ADDENDUM NO. 1

REQUEST FOR PROPOSALS (RFP) 16006 STRUCTURED CABLING SYSTEMS NORTH CENTRAL WEST VIRGINIA ADVANCED TECHNOLOGY CENTER September 8, 2015

**TELECOM
 RISER DIAGRAMS**

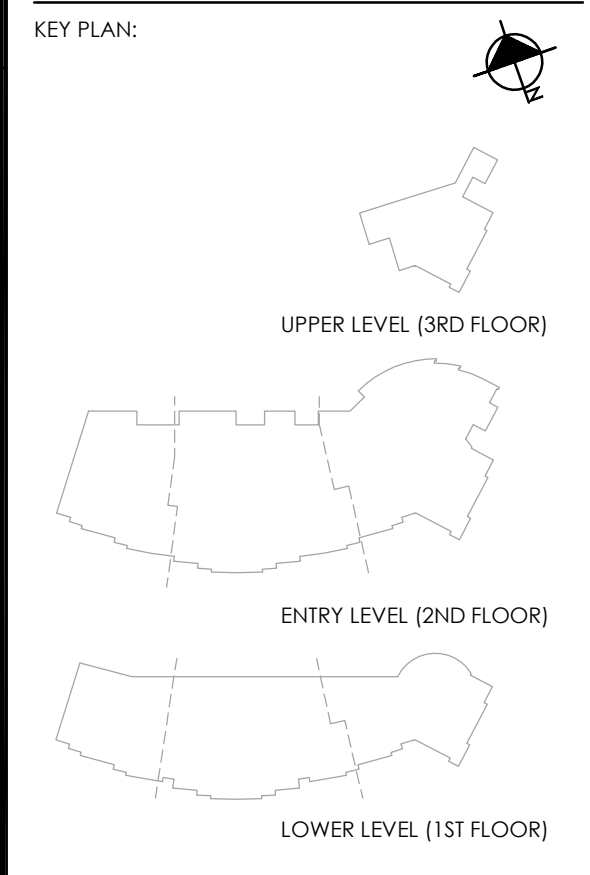
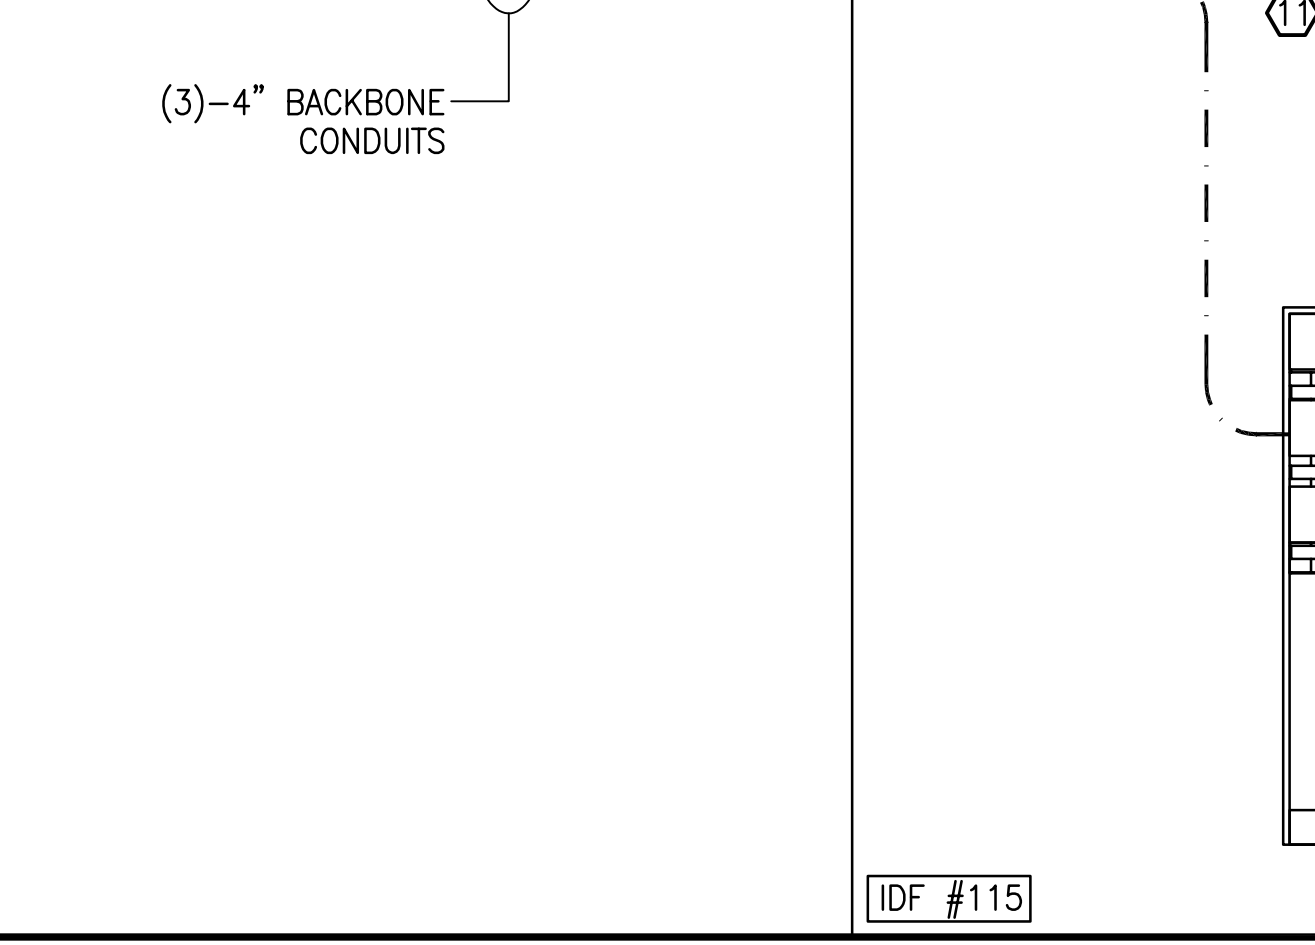
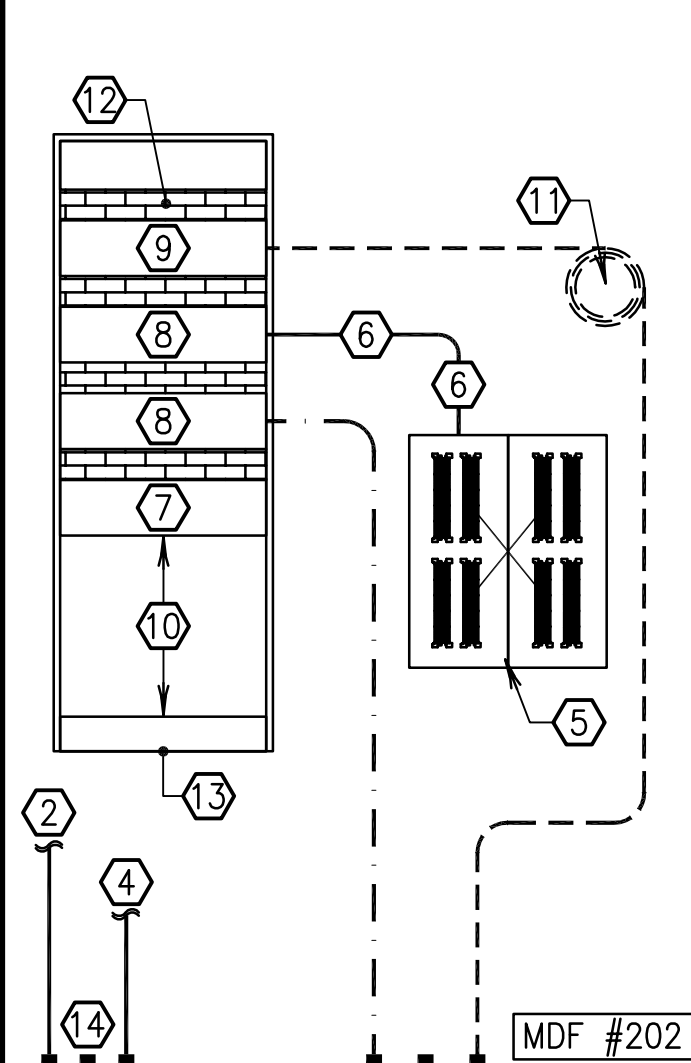
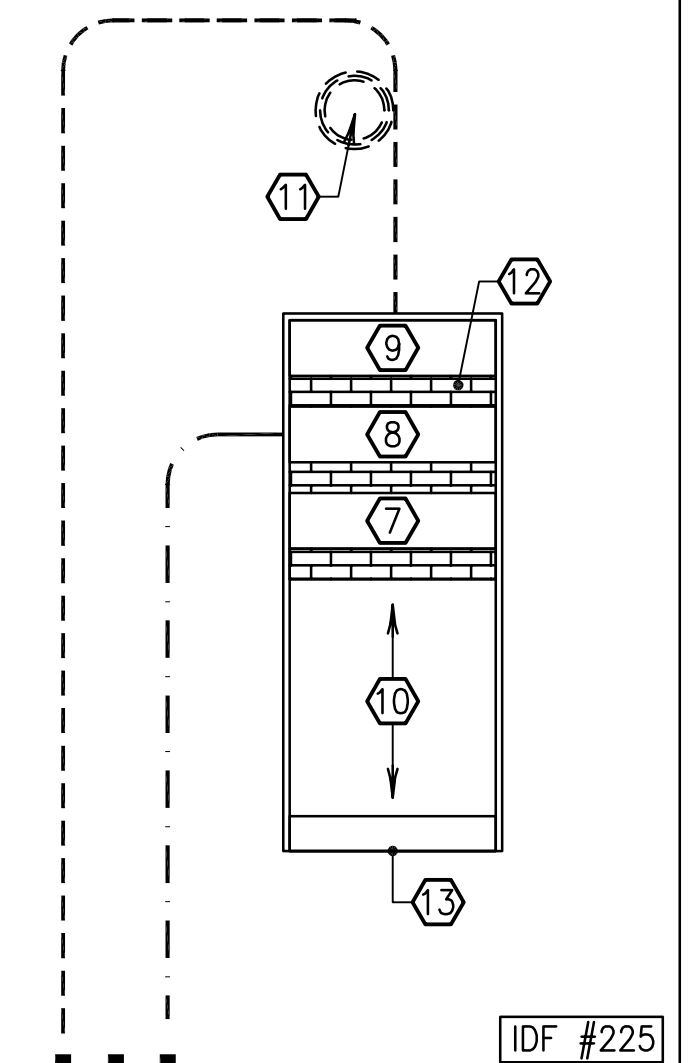
- Q1.** Drawing T401 – keynote 15 wall mount lockable Cabinet. IDF 102B shows a keynote 16, please specify if this is supposed to be keynote 15 wall mount rack or standard 4 post rack.

Answer: For IDF 102B provide server cabinet per 27 10 00 – 3.02.D
